**STATE SIGNIFICANT DEVELOPMENT
ASSESSMENT REPORT:**

***Sydney International Convention, Exhibition and
Entertainment Precinct (SICEEP), Darling Square
(formally The Haymarket), North Plot, Darling Harbour***

SSD 7021

Environmental Assessment Report
Section 89H of the *Environmental Planning and Assessment
Act 1979*

Figure 7: View of the northern (left) and southern (right) elevations of the Darling Exchange building contained within Stage 1 Approval maximum North Plot building envelope (purple) (Source: Applicant's RtS Addendum)

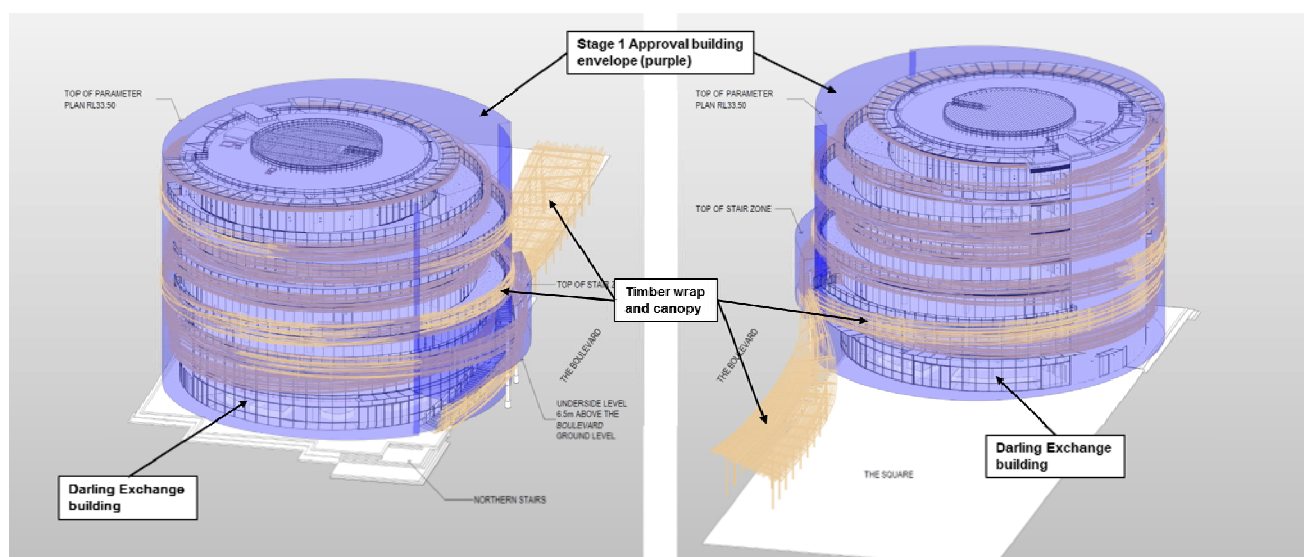
Council raised concern that as the approved building envelope for the North Plot (and across the Darling Square precinct) are larger than the building form actually proposed, there may be an expectation these volumes be developed at a later stage via a modification application. Council

The Department notes Council's concerns that the proposed Darling Exchange building fills approximately 80 percent (%) of the entire building envelope. However, the Department does not agree the Stage 1 building envelope needs to be modified as it provides a maximum building extent together with an allowance for GFA within the overall volume. The Department notes the proposed floorplates have been shifted and cantilevered relative to each other and considers the design response within the approved envelope is acceptable.

Minor sections of the timber strips/ribbons (the timber wrap), that encase the Darling Exchange Building (discussed further at **Section 5.4**), extend up to 500 mm beyond the building envelope (shown in purple at **Figure 7**). However, this is considered acceptable as the parameter plans allow for a 500 mm 'articulation zone'. Furthermore, the extension of the timber wrap out into the public open space to form an open lattice canopy (discussed further at **Section 5.4**), is considered to constitute an ancillary public domain structure and therefore not part of the building envelope. The timber wrap that encases the external stair which encroaches into the Boulevard is also acceptable as discussed in **Section 5.3.2** below.

Figure 9: The proposed 4.6 m encroachment into the 19 m ground floor level separation distance (shaded in yellow) (Base source: Applicant's RtS)

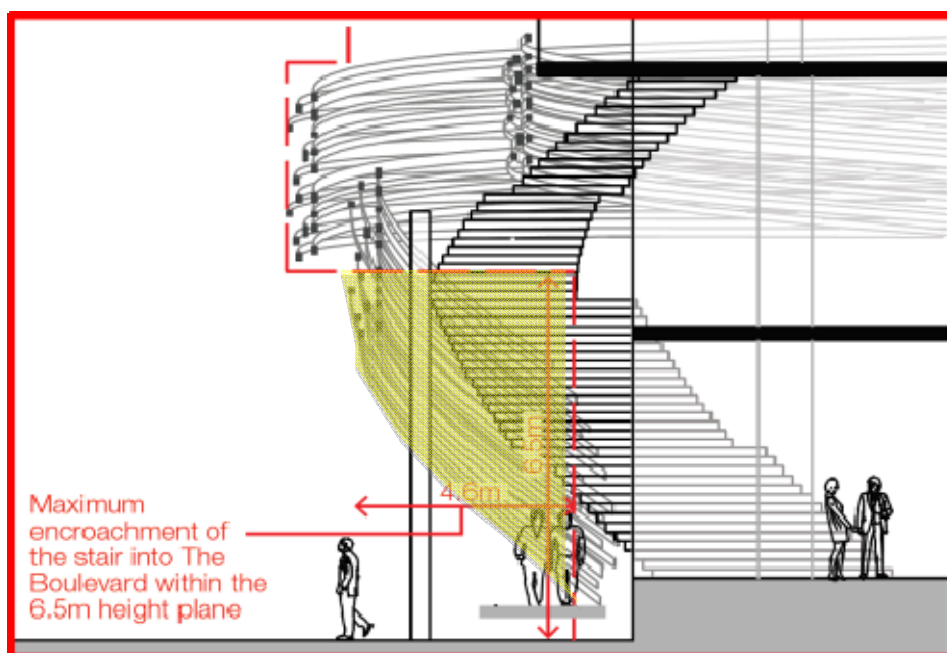
The proposed Darling Exchange building public stair encroaches into the 19 m ground floor level separation distance by a maximum of 4.6 m, therefore reducing the separation distance to a minimum of 14.4 m at its narrowest point (refer to **Figure 9**).

The Department considers maintaining the 19 m width of the Boulevard is a critical consideration in achieving the north/south pedestrian connection and visual links from China Town to Darling Harbour. However, the potential for an encroachment into the Boulevard was considered in the Department's previous assessment of the Stage 1 Approval, and was accepted in principle subject to a number of performance criteria outlined in FEAR B4A. The Department has considered the criteria in FEAR B4A, as well as the Applicant's justification in **Table 8**.

Figure 11: Location of the Darling Exchange building in relation to the neighbouring NE Plot building (Base source: Applicant's RtS)

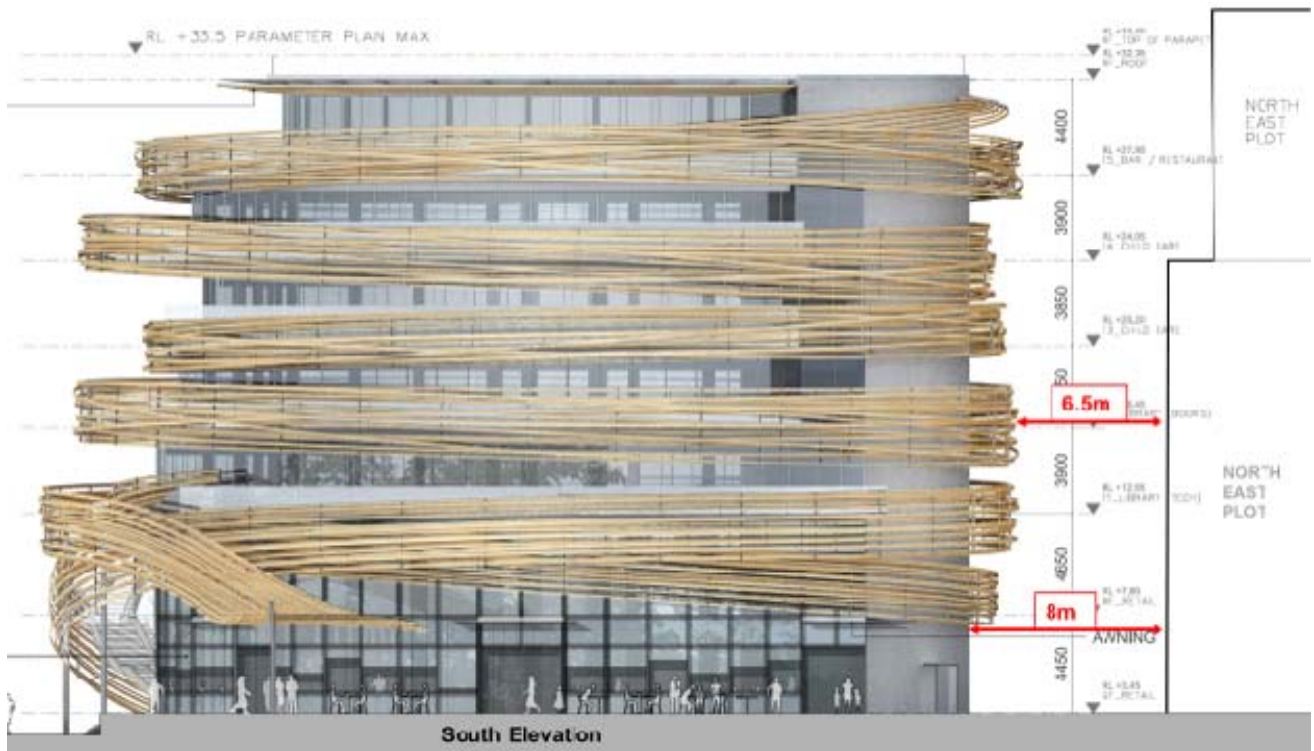
The proposed Darling Exchange building is located a minimum of 8 m from the adjacent residential North East Plot building, reducing to 6.5 m to include the timber wrap architectural feature (refer to **Figure 11**).

In response to potential overlooking, the Applicant amended the layout of the Darling Exchange, building, by rotating the building footprint so that no windows are located opposite the North East Plot building. In addition, the proposed timber wrap architectural feature provides further visual screening to balconies to interrupt any oblique overlooking.

The Department is satisfied the amendments to the building footprint and provision of the timber wrap ensure future apartments within the North East Plot building will maintain acceptable levels of privacy despite the reduction in building separation.

Figure 18: Amended servicing facilities for the Darling Exchange building (Base source: Applicant's RtS)

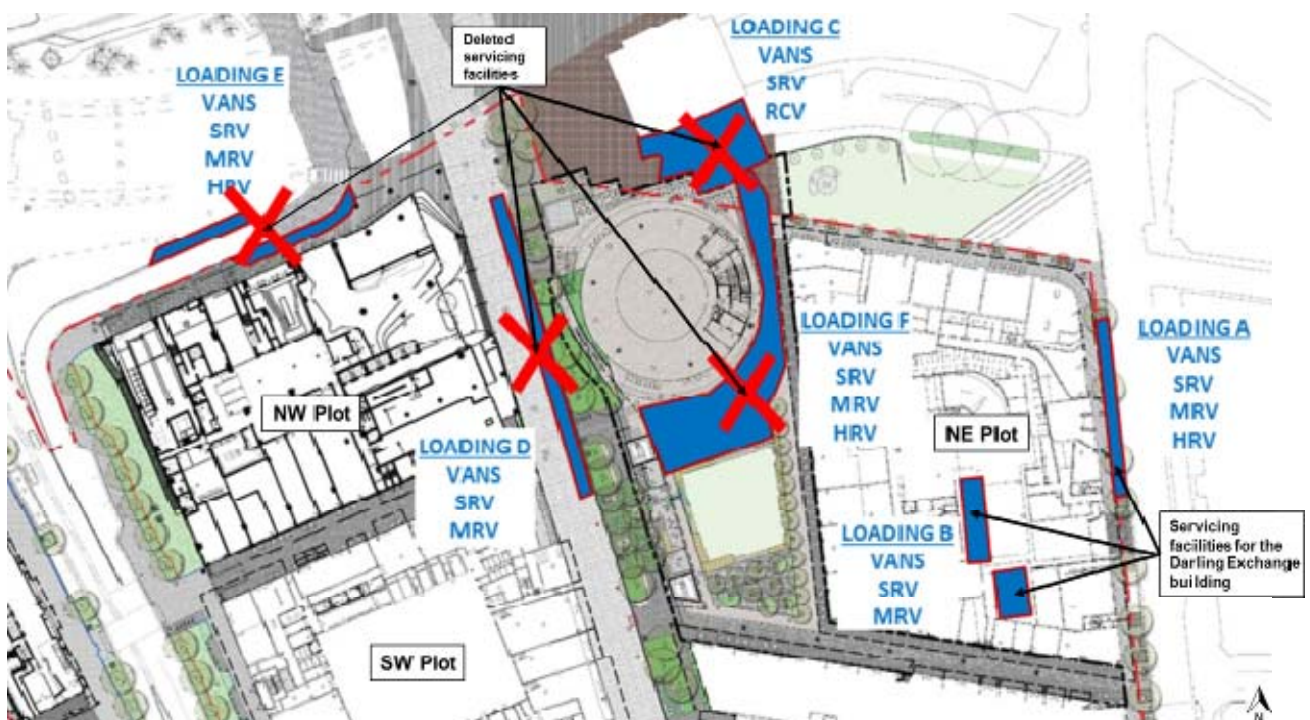
The Department, Council, TfNSW and PNSW raised operational, safety and visual impact concerns about the proposed servicing arrangements. In response, the Applicant deleted all servicing within the public domain (excluding the Harbour Street bay, which is retained) and modified the North East Plot development (SSD 6626 MOD 2) to accommodate servicing for the Darling Exchange building as shown at **Figure 18**.

- the Applicant prepare a loading dock and service vehicle management plan to ensure the space is appropriately managed; and
- the use of the North East Plot for the servicing of the Darling Exchange building is registered on title.

Figure 19: Winter Solstice shadow cast by the Darling Exchange building at noon (shaded in pink) and the North Plot building envelope (red line) (Base source: Applicant's RtS)

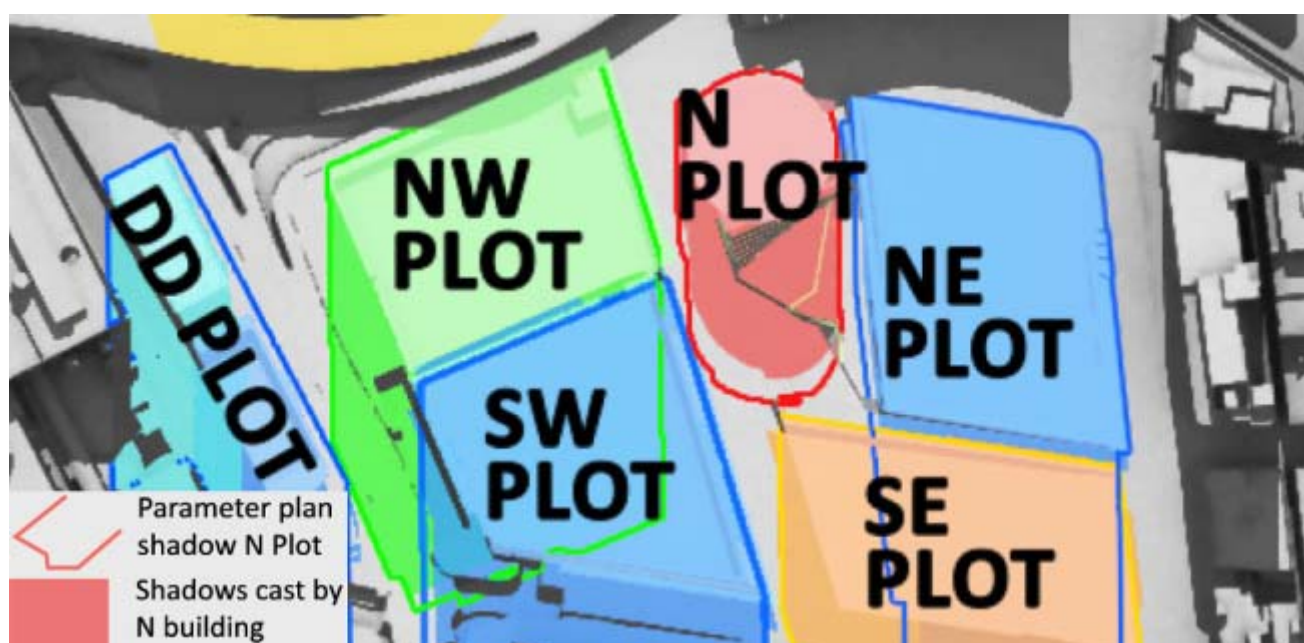
Concern was raised in the public submission about the potential overshadowing of the public open space. PNSW has also commented that the height of the Darling Exchange building should not result in additional overshadowing of the public square above what was approved by the Stage 1 Approval.

The Applicant contends the height of the Darling Exchange will provide for a building of an appropriate civic scale. Further, the proposal is wholly contained within the approved North Plot building envelope (refer to **Figure 19**).

The Department is satisfied the proposal will not result in unacceptable overshadowing impacts on the public open space, as:

- the shadow studies submitted with the proposed modification demonstrate the proposal has an acceptable impact on solar access to Darling Square open space in accordance with the conclusions of the Concept Approval (**Figure 19**) and will ensure the southern portion of the public open space would continue to achieve direct sunlight between 11:30 am and 1:30 pm in mid-winter;
- the Darling Exchange building is of a lesser scale than the maximum size of the North Plot building envelope, and includes cantilevered levels, which allow for additional sunlight to penetrate through to the open space in winter months; and
- the height of the Darling Exchange building matches the podium heights of the other Darling Square buildings facing the open space.

Figure 20: Locations of proposed signage zones (Base source: Applicant's RtS)

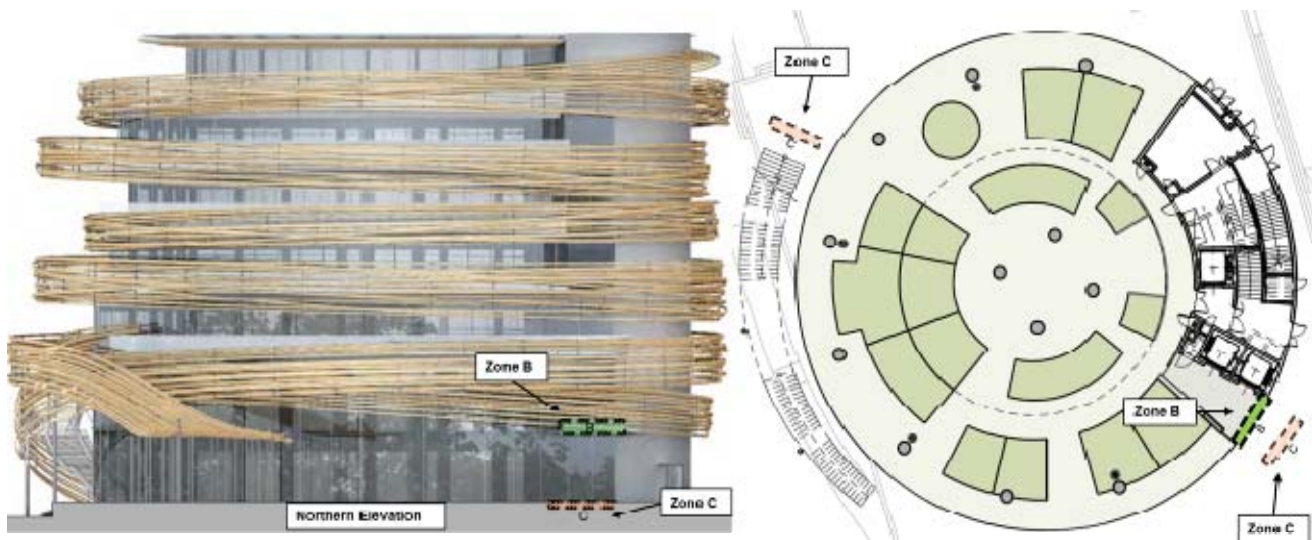
The proposal includes the provision of three building identification signage zones, one will be located on the south-eastern ground floor elevation of the building and the remaining two within the pavement (refer to **Table 10** and **Figure 20**).

The Department has considered the principle of the proposed signage zones and is satisfied all future signs will be capable of being appropriately positioned, proportioned and integrated into the design of the building and is therefore acceptable. In addition, the Department is satisfied the proposed signage zones are appropriately dimensioned and will not result in future signage that dominates or detracts from the Darling Exchange building.

The Department, therefore, supports the proposed signage zones and is satisfied they meet the key assessment criteria in SEPP 64 (refer to **Appendix D**). Notwithstanding, the Department recommends a condition requiring future signs within the signage zones, including any illumination, be subject to separate approval.
